ND-16-1855
10 CFR 50.90

Southern Nuclear Operating Company
Vogtle Electric Generating Plant Units 3 and 4
Revised Request for License Amendment:
Structural Design of Auxiliary Building Floors (LAR-16-009R3)

**Revised Request for License Amendment Regarding
Structural Design of Auxiliary Building Floors
(LAR-16-009R3)**

**Figure 3H.2-1*****[General Layout of Auxiliary Building]****

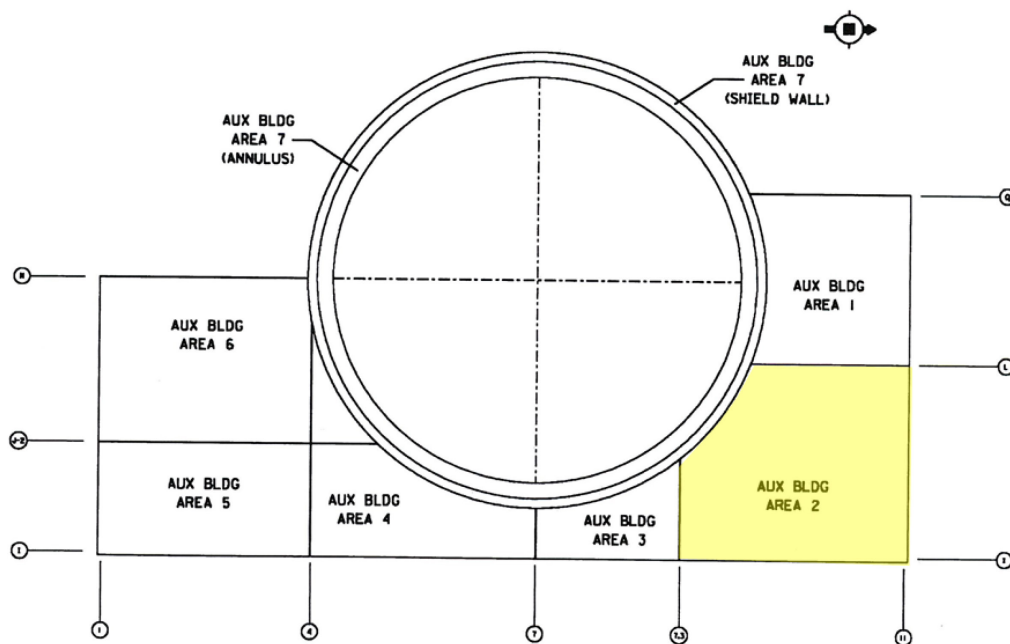
Per UFSAR Figure 3H.5-9 (Sheet 1 of 3), the Main Control Room Ceiling at Elevation 135'-3" is enclosed by column lines I and L, and column lines 9.2 and 11, and this area is within the range of AUX BLDG AREA 2 as shown in UFSAR Figure 3H.2-1. Further, Area 1 is identified in Subsection 3H.5.2.2 and Table 3H.5-11 as the floor at elevation 135'-3", but between column lines M and P. Therefore, the title of UFSAR Table 3H.5-13 should be "DESIGN SUMMARY OF FLOOR AT ELEVATION 135'-3" AREA ~~1~~2 (MAIN CONTROL ROOM CEILING)".

Figure 1

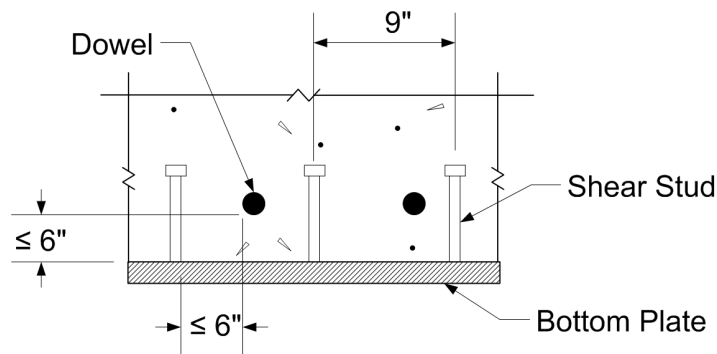
The dowels are designed to be at or below the height of the 6" tall shear studs and within 6" of distance from the shear studs as illustrated in Figure 1. The shear studs are spaced at 9" on center. The dowel spacing varies between floors; however, the dowels remain within 6" distance from the shear studs for the CA20 and auxiliary building finned floors.

Tension in the bottom plate is transferred to the reinforcing bar dowels anchored in the module wall by the gradual transfer of stress via the shear studs interacting with the dowel extending along the bottom plate. The reinforcing bar development is determined by the ACI 349 Class B lap splice length because the force transfer mechanism between the bottom plate and the reinforcing bar dowel is similar to a reinforcing bar noncontact lap splice. A maximum of 6" clear distance between the dowels and the shear studs is maintained to be consistent with the ACI 349 Section 12.14.2.3 requirements for a noncontact lap splice. The shear studs provide confinement for the lower reinforcing bar dowels and act as transverse reinforcement to control splitting parallel to the bottom plate. In addition, the bottom plate acts as transverse reinforcement to control splitting perpendicular to the bottom plate.

DESIGN SUMMARY OF FLOOR AT ELEVATION 135'-3"
AREA ~~4-2~~ (MAIN CONTROL ROOM CEILING)

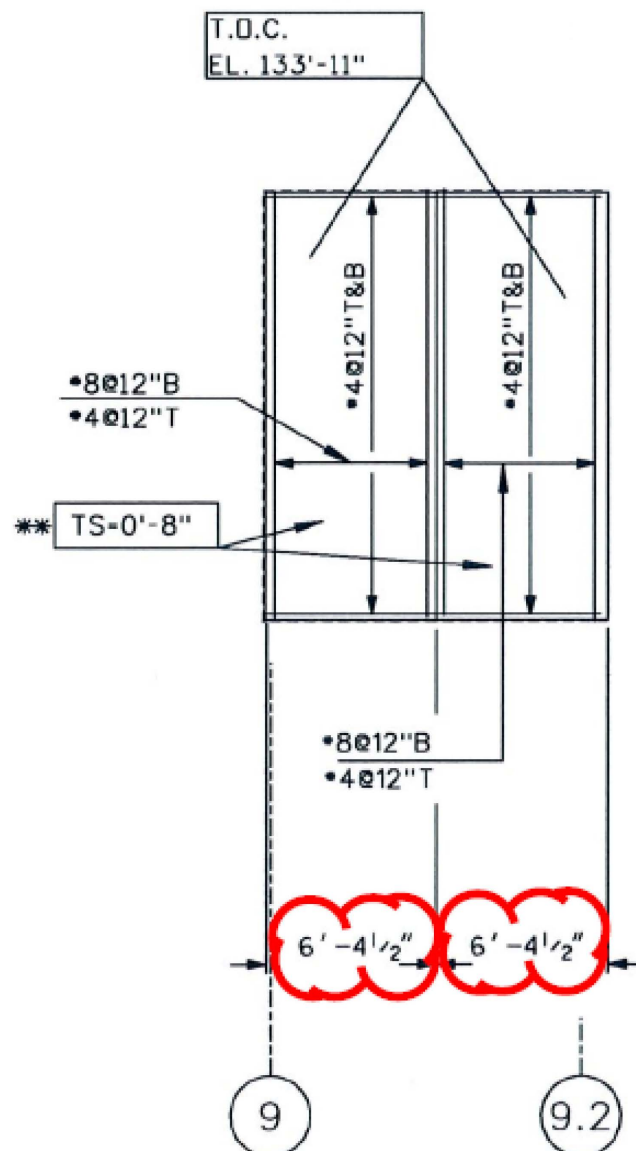
UFSAR Table 3H.5-13, Design Summary Of Floor At Elevation 135'-3" Area 1 (Main Control Room Ceiling) – Revise the title of this table to read as shown below.

UFSAR Table 3H.5-13, Design Summary Of Floor At Elevation 135'-3" Area 1 (Main Control Room Ceiling) – Revise the information in the table as shown below.

- K. Revise UFSAR Table 3H.5-13 as follows: (Change Activity 7)
 - 1. Revise the table title to change the area identified in the title.
 - 2. Reformat the table and add text to improve comprehension.

- 3. Define construction loads.
 - 4. Revise the calculation results for maximum bending moment.
 - 5. Define tension steel.
 - 6. Add an exception for reinforcement near penetrations and other interferences.

- 7. Revise to add values to the table for the reinforcement to resist negative bending.
 - 8. Add an exception for shear studs near penetrations and other interferences.

- 9. Add a clarification that the design shear strength is not reduced for in-plane axial forces.
 - 10. Remove from the table the information on shear stud calculated required spacing.

FLOOR EL. 133'-11"
 (PRECAST CONCRETE)
 NOTES 1, 3, 6, 7, 16, 17

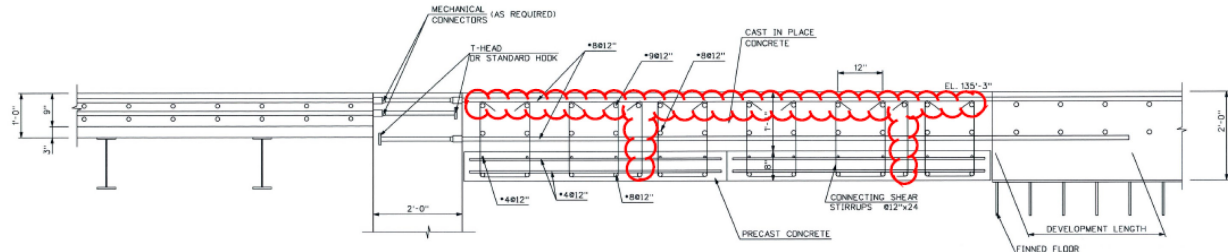
**UFSAR Figure 3H.5-8, Auxiliary Building Operations Work Area (Tagging Room) Ceiling –
 Revise the information for Floor El. 133'-11" (Precast Concrete) as shown below.**

- L. Revise UFSAR Figure 3H.5-8 as follows: (Change Activity 9)
 - 1. In the view labeled Floor EL. 133'-11" (Precast Concrete) change the panel width from 5'-11" to 6'-4½".

UFSAR Figure 3H.5-9 (Sheet 1 of 3), Auxiliary Building Finned Floor – Revise the information as shown below.

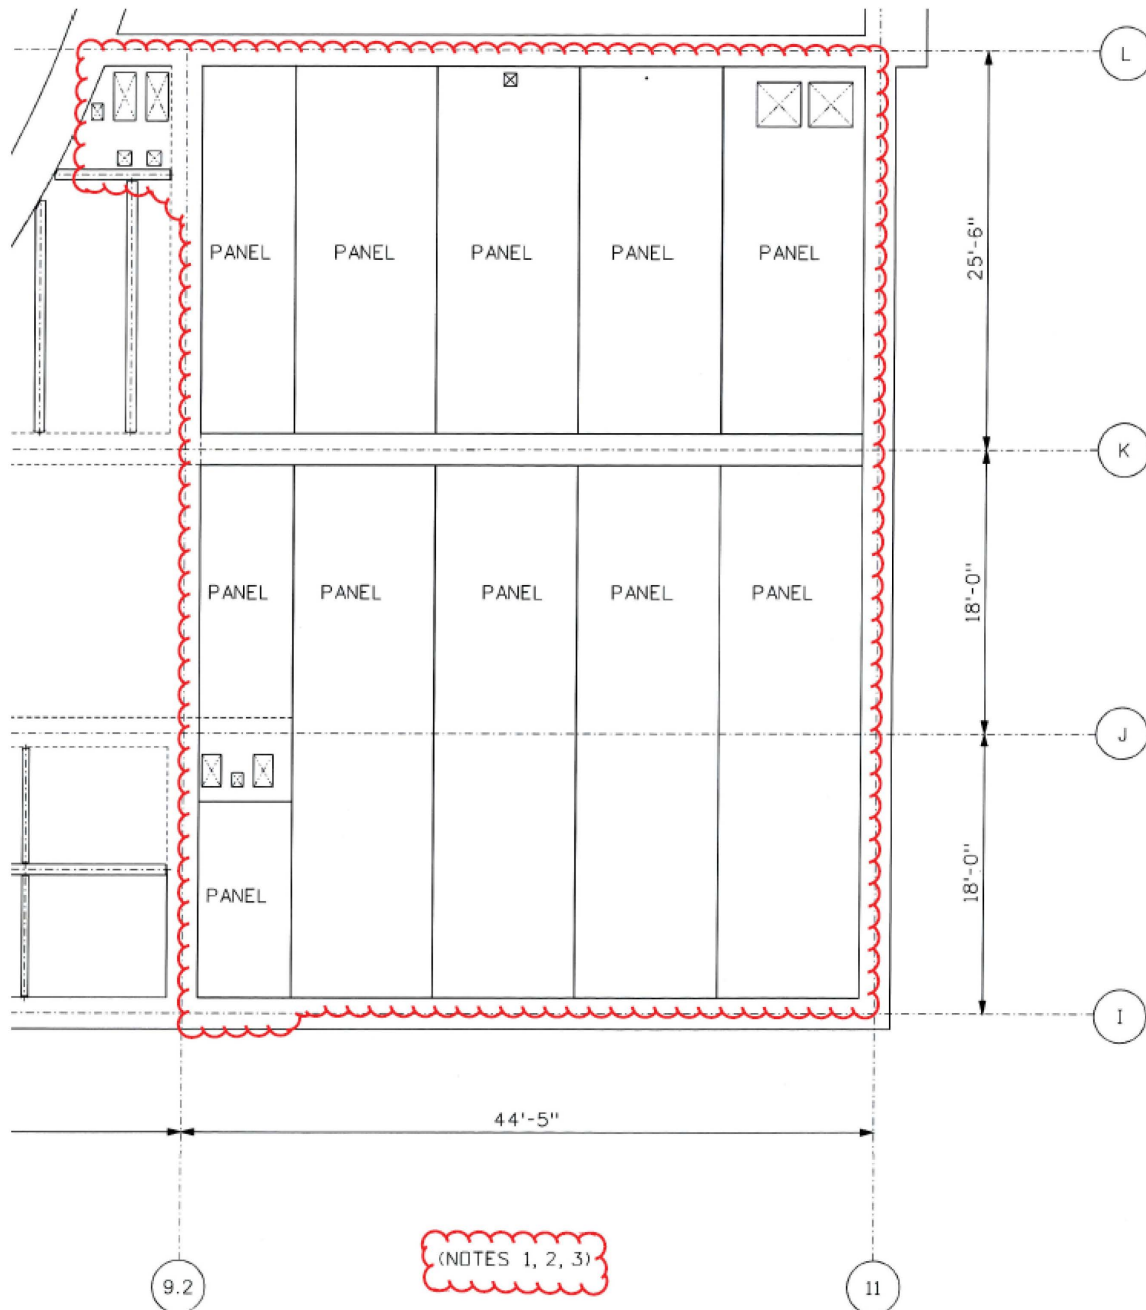
UFSAR Figure 3H.5-9 (Sheet 1 of 3), Auxiliary Building Finned Floor – Revise the information to add the Notes shown below.

- M. Revise UFSAR Figure 3H.5-9, Sheet 1, as follows: (Change Activities 1, 3, 4, 5, and 8)
 - 1. Revise the figure to show six finned floor steel panels between column lines 9.2 and 11 from column lines I through K, and show five finned floor steel panels between column lines 9.2 and 11 from K through L.

2. Revise the figure to move the openings for HVAC ducts from along column line 11 near column lines I and J to along column line L near column line 11, and to reconfigure the openings adjacent to column line 9.2.

UFSAR Figure 3H.5-9 (Sheet 2 of 3), Auxiliary Building Finned Floor – Revise the information to add the Notes shown below.

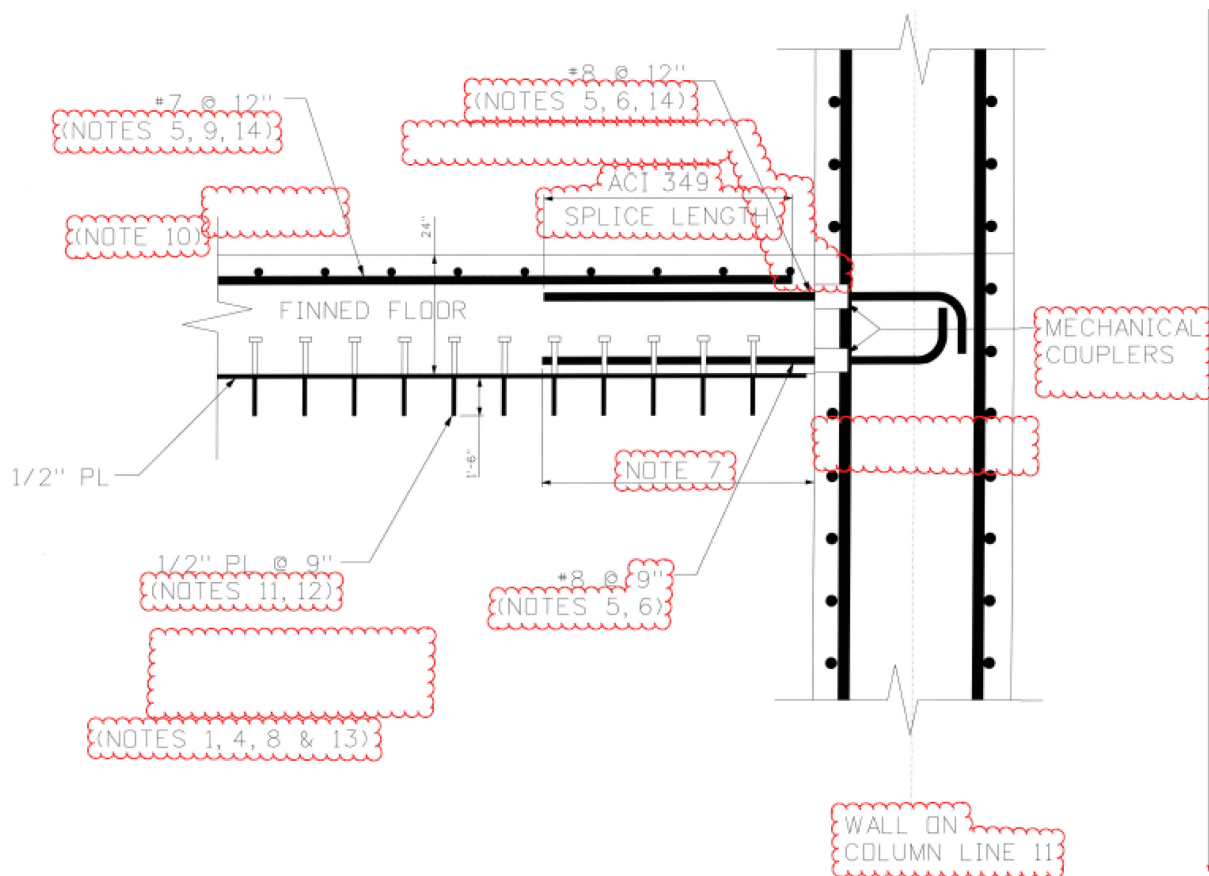
For the gap shown on Figure 3H.5-9, Sheet 2, the NRC staff asked whether there will be any gap filler, and whether the gap filler is 3-hour fire rated. Licensee to address.

On SNC LAR-16-009R2 page 10 of 12 and page 11 of 12, the NRC staff requested to add a note to explain the variation of hook orientation in CA20 floors and finned floors. The NRC staff asked the licensee to add hook orientation description in either LAR and UFSAR 3.8.4.4.1 changes or add Note to UFSAR Figure 3H.5-9 (Sheet 2 of 3) to allow for variation. Licensee will investigate.

- N. Revise UFSAR Figure 3H.5-9, Sheet 2, as follows: (Change Activities 1, 2, 5, 6, and 8)
1. Revise spacing of the bottom reinforcement bar dowel to @9".

2. Remove reference to construction joint.
 3. Remove designation of 135'-3" elevation; replace with Note 10.
 4. Remove size of the bottom dowel length; replace with Note 7.

5. Remove size of the top dowel length, replace with "ACI 349 SPLICE LENGTH". Move the top reinforcement dimension line from the face of the wall to the end of the top reinforcement.

6. Remove information on gap between steel plate and wall.
 7. Replace the term “Mechanical Splices” with “Mechanical Couplers”.
 8. Remove North–South designator.

9. Revise wall designation to say “WALL ON COLUMN LINE 11”.
 10. Add identification of applicability of Notes 1, 4, 5, 6, 7, 8, 9, 10, 11, 12, 13 and 14 on the figure.

The gap shown on Figure 3H.5-9, Sheet 2 is a construction feature related to placement of the bottom plate. Once concrete is placed, the concrete closes any gap between the module floor and the adjacent wall. This final configuration provides the 3-hour fire barrier.

On the markup of UFSAR Figure 3H.5-9, add the sentence “**THE HOOK ORIENTATION IN CA20 FLOORS MAY VARY FROM THAT OF FINNED FLOORS**” in note 6 (original note 4) after “IN CERTAIN LOCATIONS SOME CONNECTING DOWELS ARE DEVELOPED INTO ADJACENT REINFORCEMENT CONCRETE FLOORS INSTEAD OF CONNECTING TO HOOKS OR HEADED REINFORCEMENT IN THE WALL.”
